UNITED STATES PATENT AND TRADEMARK OFFICE

APPLICATION NO.	FILING DATE	FIRST NAMED INVENTOR	ATTORNEY DOCKET NO.	CONFIRMATION NO.
10/777,650	02/13/2004	Ma-Li Wang	63349.00002	5617

Office Action Summary

DETAILED ACTION

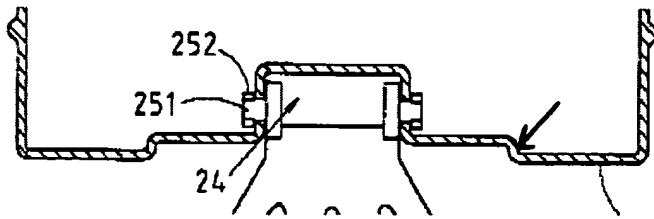
The evidence of the recess in the inclined plane portion is best seen in Figs. 9 -

11. Beginning with Fig. 10, note the dotted line extending from the anchored portion toward the front of the bag. This dotted line would not be shown were there not a surface for which the dotted line is representative. Fig. 9 discloses, rather

conclusively, that the surface disclosed by the dotted line of Fig. 10 is the vertical surface separating a recess from the inclined plane portion of the base.

The height of the vertical surface corresponds to the thickness of the support piece. Additionally, the recess shown in Fig. 9 is of a width that corresponds to the width of the support piece, and the dotted lines in Fig. 10 are also of the same shape as to correspond to the support piece. This vertical surface is not shown in Fig. 11, as it would be covered by the support piece.
